Product: A/V Receiver

Hardware Technical Bulletin: T773-H2005-05R

Subject: Static protection for muting transistors

Technical Bulletin T773

Figure 1

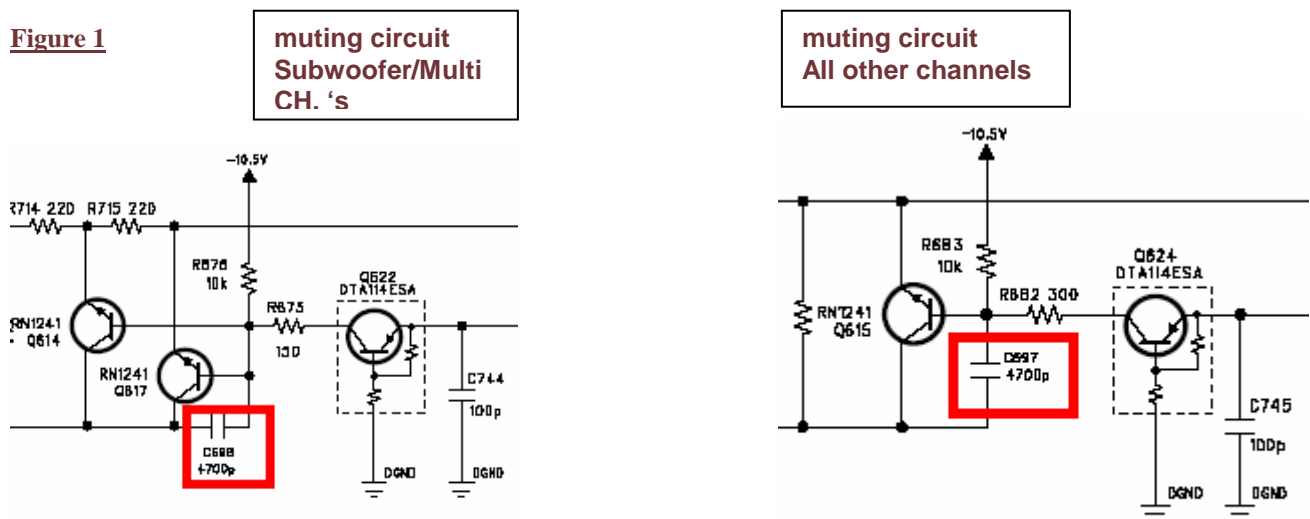
SOLUTION: Replace the transistor and install a 4700 pF capacitor between the base and collector on the pre amp pc board, as shown in the following two schematics. The use of a surface mount capacitor is recommended. Placing the capacitor on the bottom of the board between the base and collector of each muting transistor is preferred. See figure 2 on page 2.

Note: It is recommended to install this capacitor to each channel's muting transistor. The following are the designations of the muting transistors, Q608, Q609, Q610, Q611, Q612, Q613, Q615, Q617 and Multi source muting transistors Q632, Q633.

Figure 2

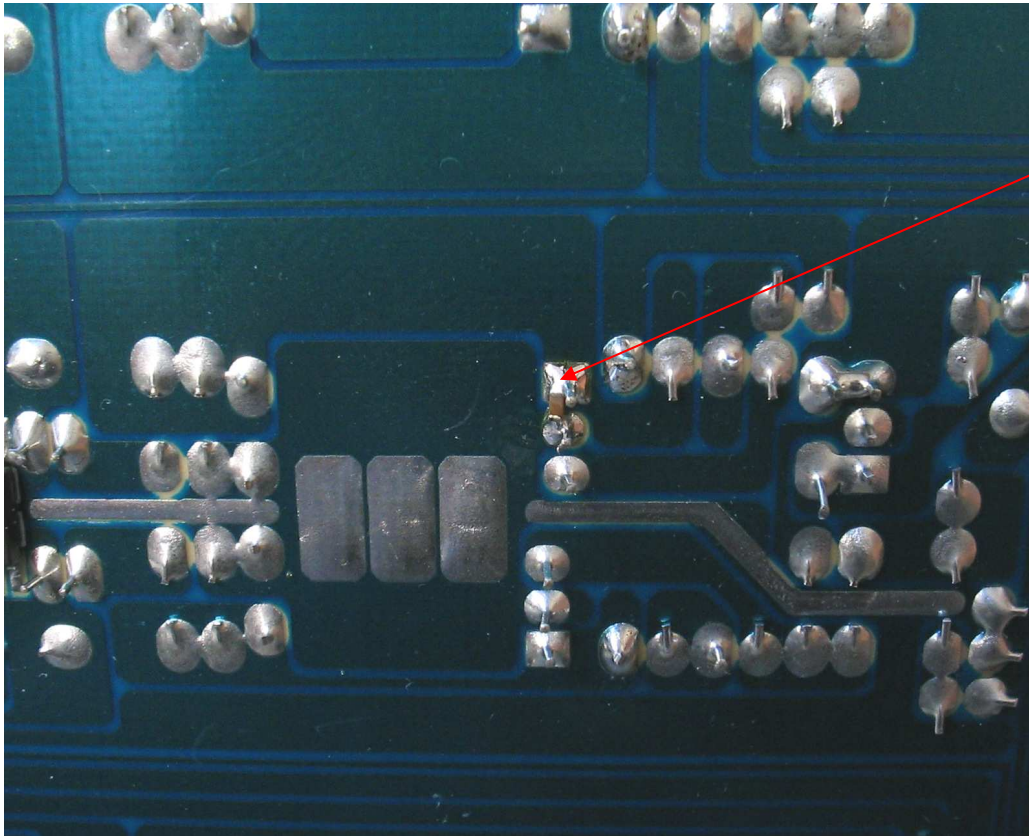
4700pF surface mount capacitor between base and collector pins of muting transistor on the pre amp pc board

Figure1

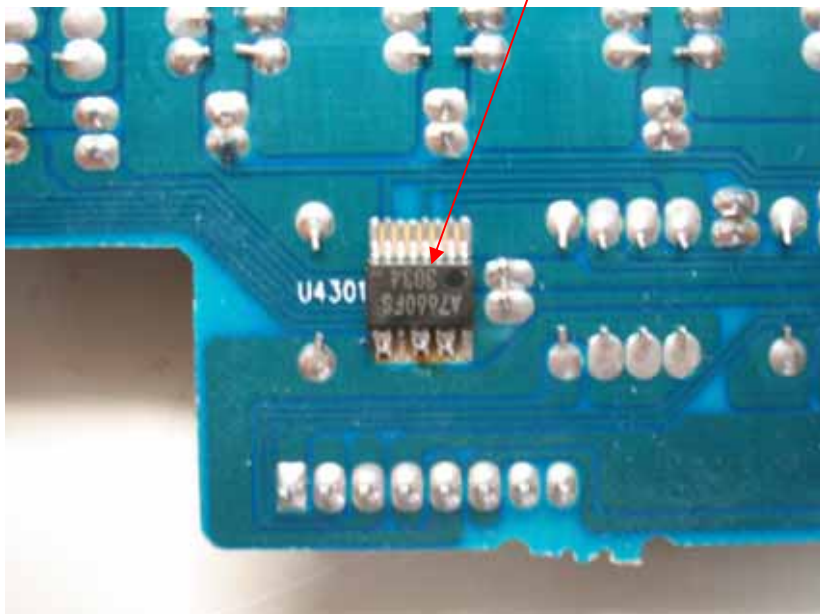
DESCRIPTION: To improve the compatibility of HDTV signals with some TV/Monitors.

REASON: When decoding HDTV signals some TV/Monitors may experience horizontal sync loss.

SOLUTION: Perform the following change to the Component video board.

On the component video PCB U4301

- A) Link the following pins on U4301;
- Pins 9 to 10
 - Pins 12 to 13
 - Pins 14 to 15

Figure 2

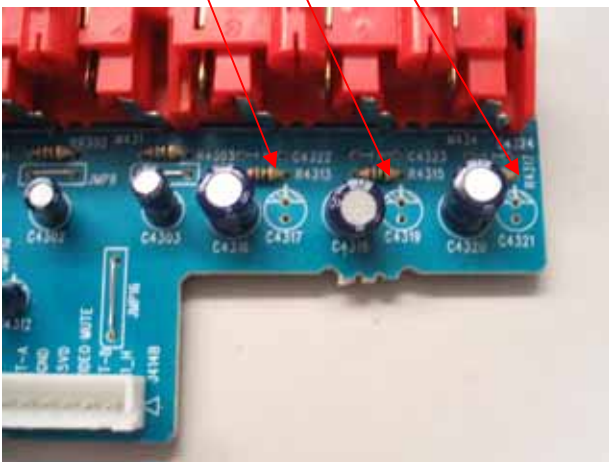
B) Remove C4317, C4319, C4321.

Figure 3

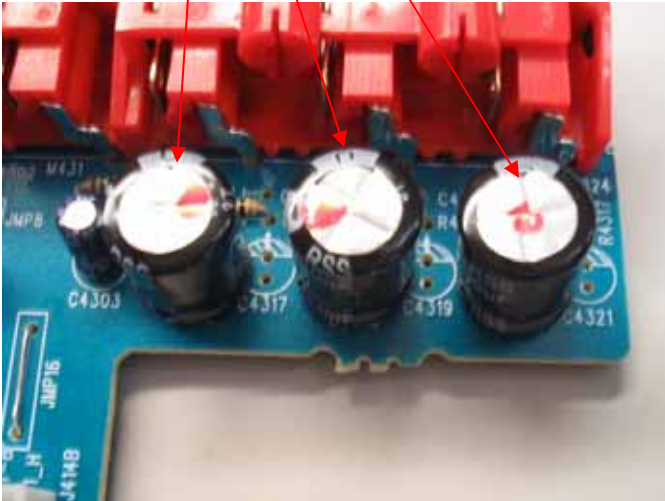
C) Replace C4316, C4318, and C4320 with 1000 uF 6V.

Figure 1

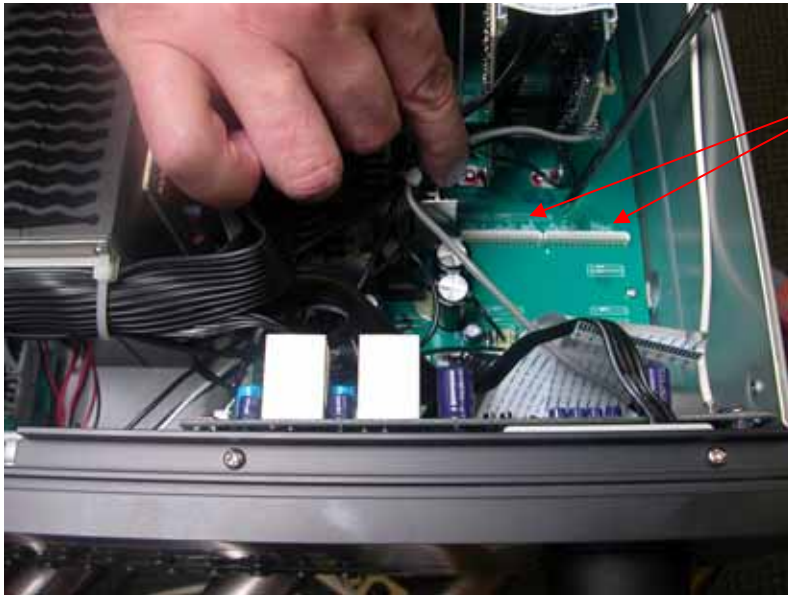
SOLUTION: *Clean all ribbon connectors using an eraser or preferably a non alcohol based cleaner which will leave no residue. See figures 1, 2 and 3.*

Locate and remove the ribbon cables, front panel cables shown.

Figure 2

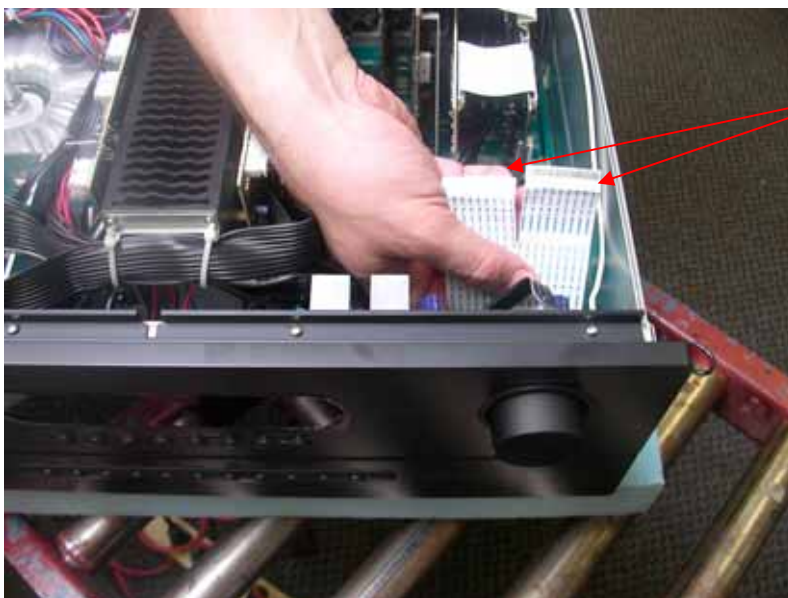
Ribbon cables are easily unplugged from these connectors.

Figure 1

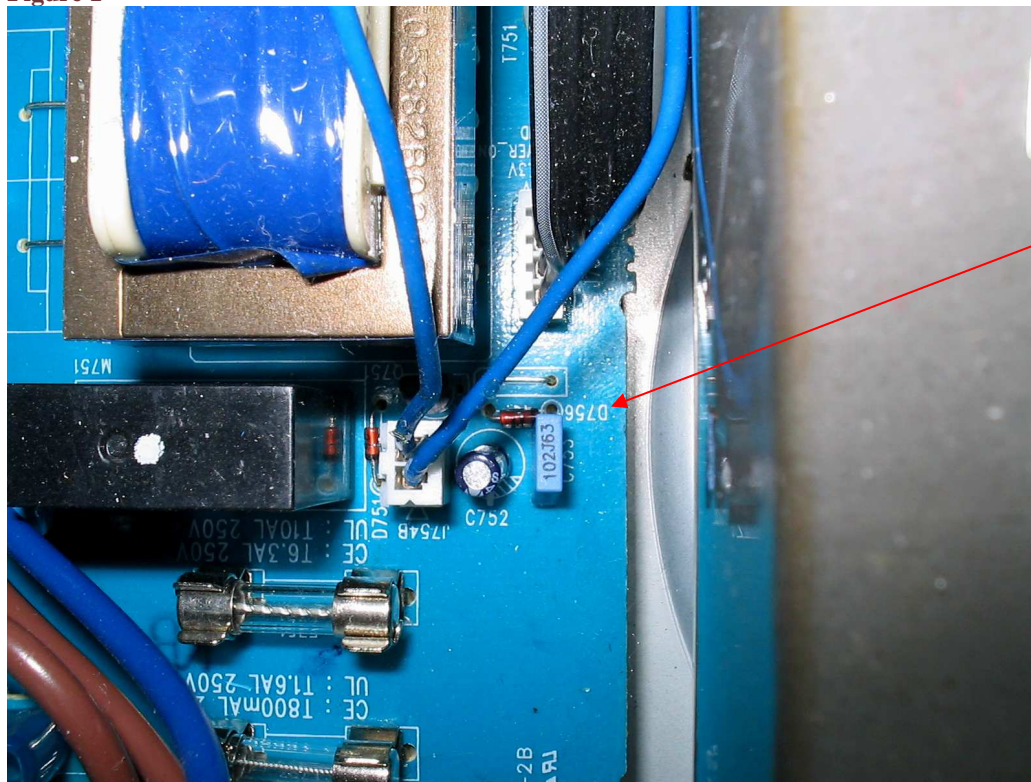
DESCRIPTION: Unit may shut down, shortly after turn on.

REASON: There is a diode on the standby board that maybe operating intermittantly.

SOLUTION: Locate and identify D756 on the standby board. Change only if the diode is a 1N4148. Change from a 1N4148 to a 1N4004 or equivalent. See figure 1 for details.

D756
CHANGE
FROM
1N4148 TO
1N4004
